LARAMIE COUNTY PLANNING & DEVELOPMENT DEPARTMENT

MEMORANDUM

TITLE: Review and Action on a Subdivision Permit and Plat for Eagle Ranch, Situated in a Portion of the East Half of Section 10, Township 13 North, Range 60 West of the 6th P.M., Laramie County, WY.

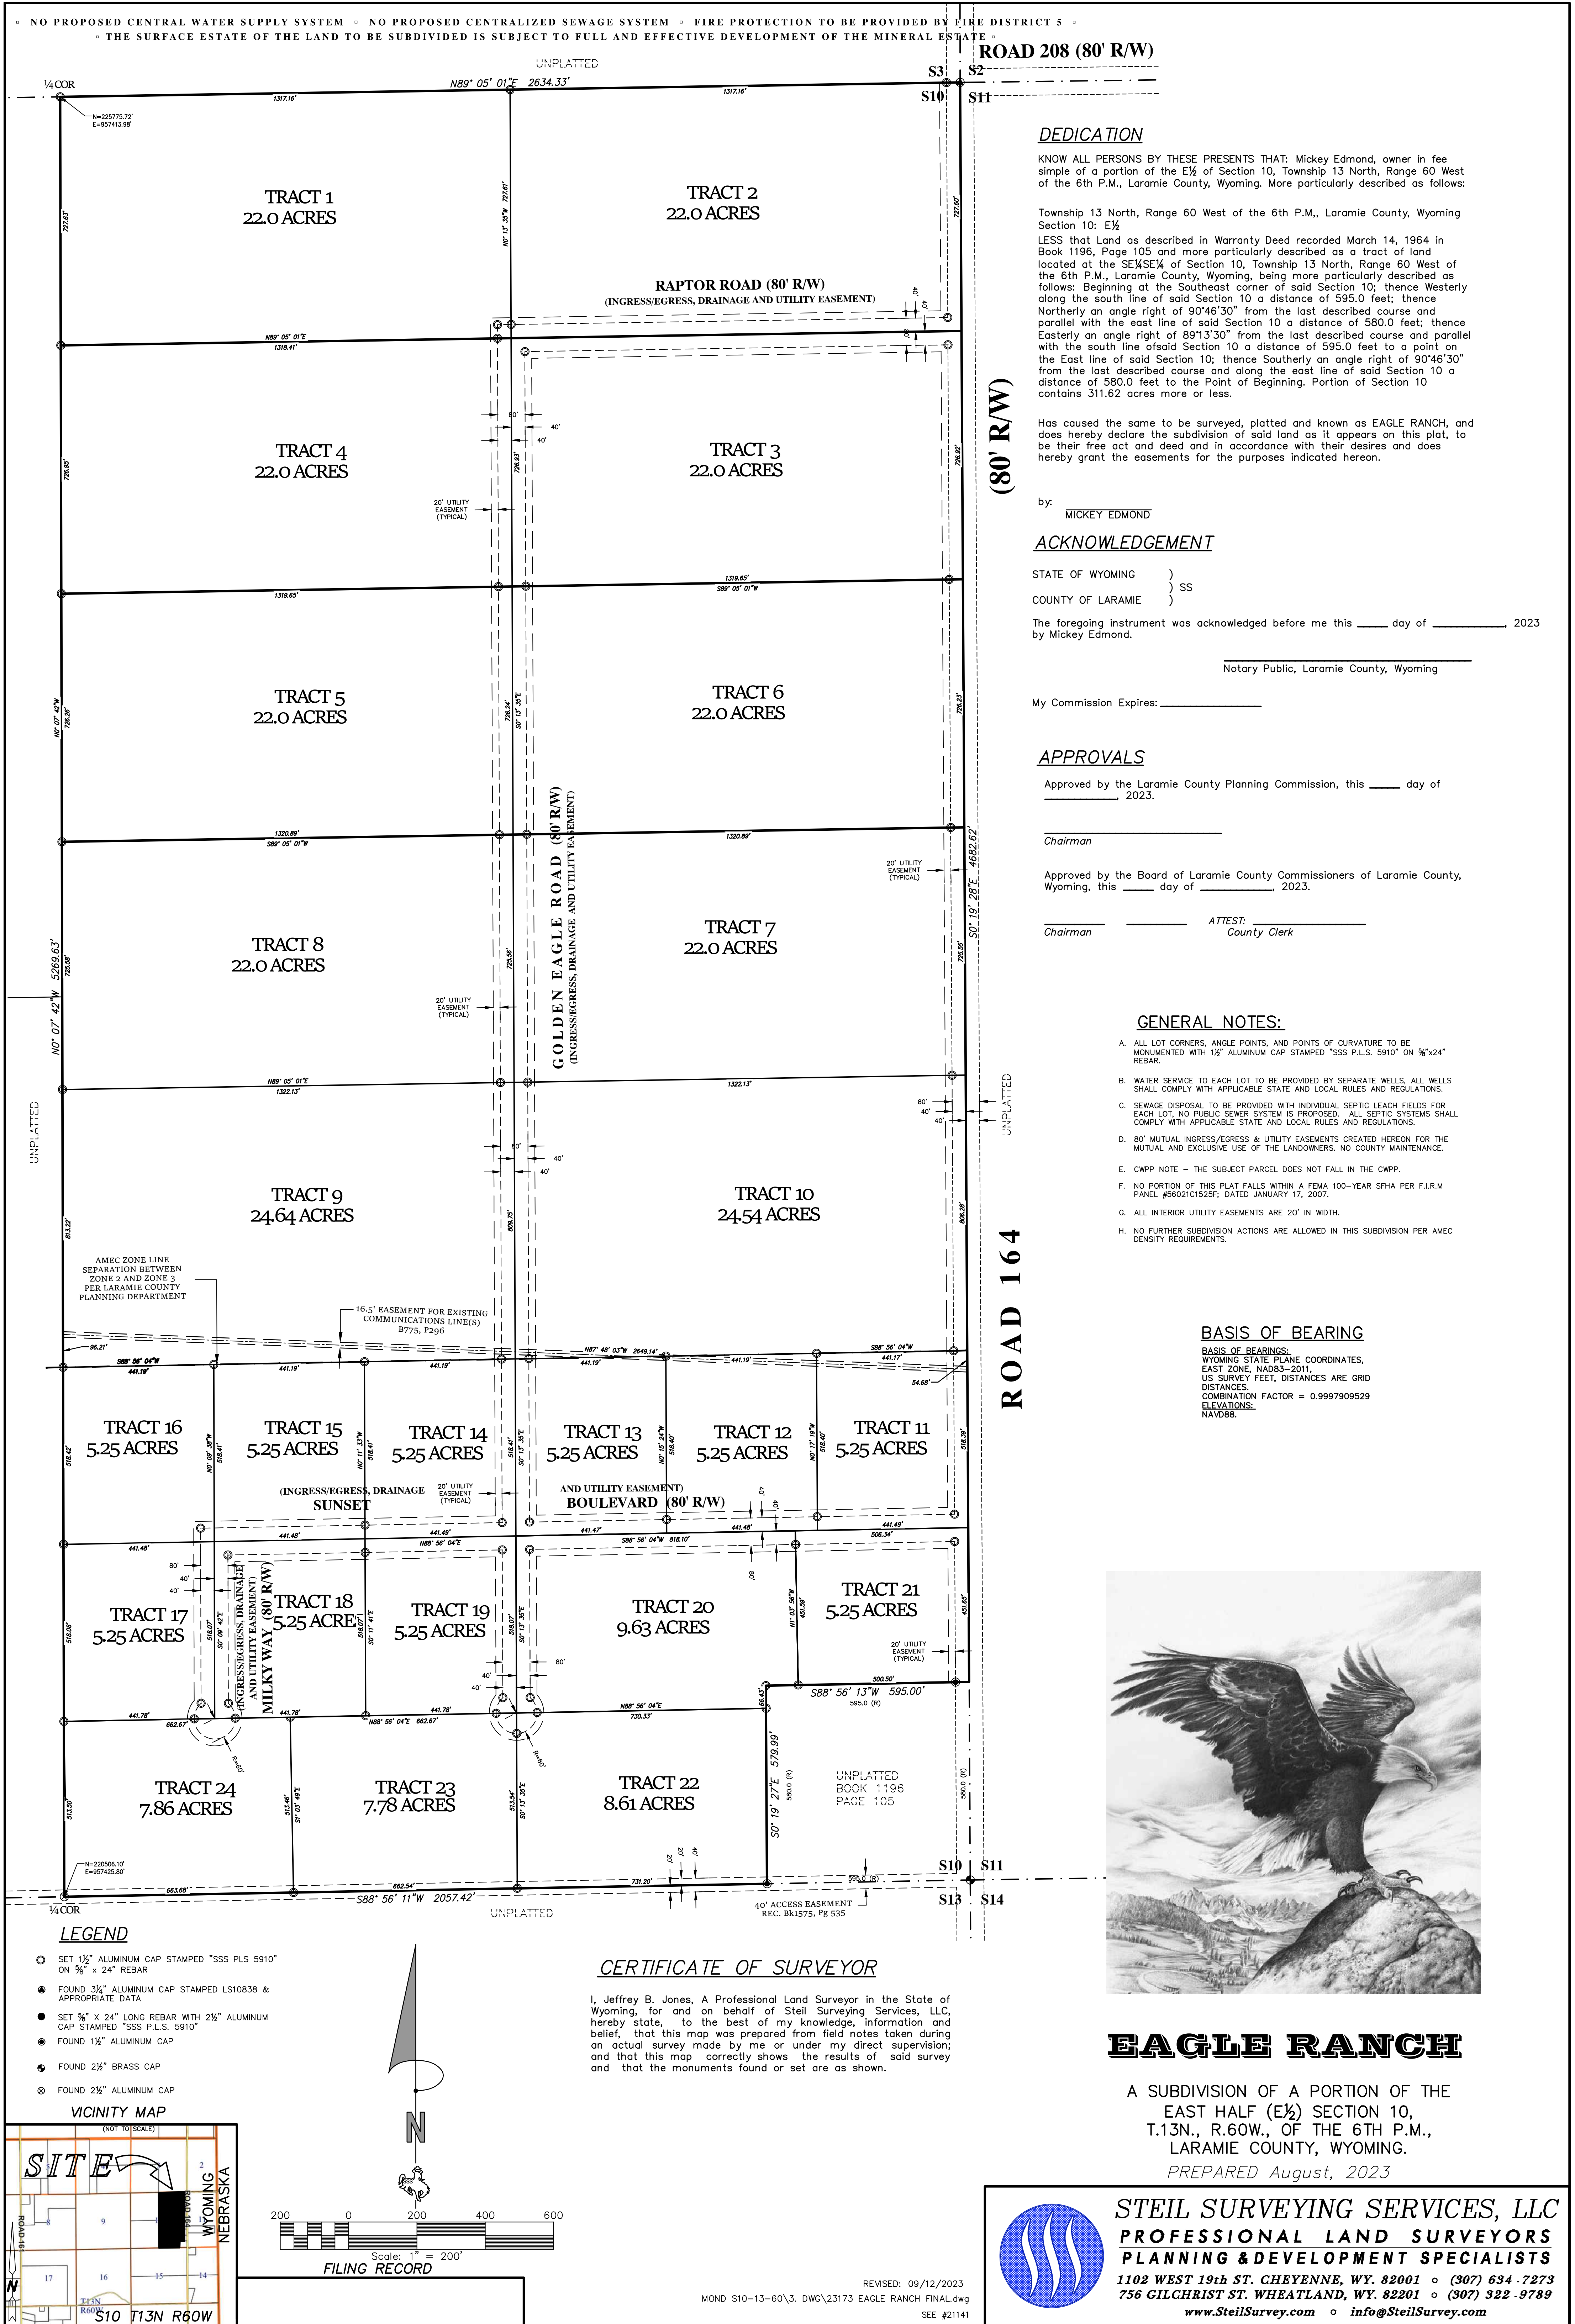
1. Since the northern property line is on a Section line and Road 208 exists to the east, this plat should include dedicating 40 of ROW for Road 208 to extend to the west and for future development.
2. A note shall be added to the plat indicating "All Tracts are to be accessed off internal roadways/access easements."

09/05/2023	09/05/2023	Application	PZ-23-00089	GENERAL	Second Review 1. Per the LCLUR, the distance between roadway accesses for the speed on this roadway is 550 feet. Therefore, Raptor Road needs to be a minimum of 550 feet from Road 208. The response indicated it will move to comply on Final Plat but I do not see that it was moved on the revised Final Plat. 2. My original comment indicated Since the northern property line is on a Section line and Road 208 exists to the east, this plat should include dedicating 40 of ROW for Road 208 to extend to the west and for future development. Between 180 and the Wyoming/Colorado state line, there is only one existing east/west roadway that connects Road 161 and Road 164 which is Road 206. The Planning Commission and County Commissioners will need to determine if it is good transportation planning to plan on allowing Road 208 to extend to the west to potentially tie into Road 161. By doing this, it allows for more east/west connections instead of relying on just the one that exists now. It also would minimize the potential of landlocking potential developable property that lies between Road 161 and Road 164. There are 3 miles of property between Road 161 and Road 164 that could have difficulty with access if property adjacent to Road 161 and Road 164 is developed with internal roadways only. 3. The original comment stated There are several dashed line types on the plat. It would be helpful and useful, especially to the lay public, if there were a LINE TYPE LEGEND on the	SCOTT.LARSON@LARAMIECOUNTY.WY.GOV

plat to help identify the various uses of the various specific line types. The response stated that line types are all different. However, the same line type used for the utility easements is used for the ingress/egress and drainage easements and the dedicated ROW for Road 164 and Road 208, which are three completely different types of easements/ROW and should be distinguished by three different types of line types.

1. RAPTOR ROAD IS 730 FEET FROM RD 208
2. OWNER DOES NOT WISH TO DEDICATE ROW. 208 DOESN'T EXIST AGAIN TO THE WEST FOR 10 MILES. FUTURE DEVELOPMENT OF THIS ROAD IS HIGHLY UNLIKELY.
3. ALL LINE TYPES ARE DIFFERENT
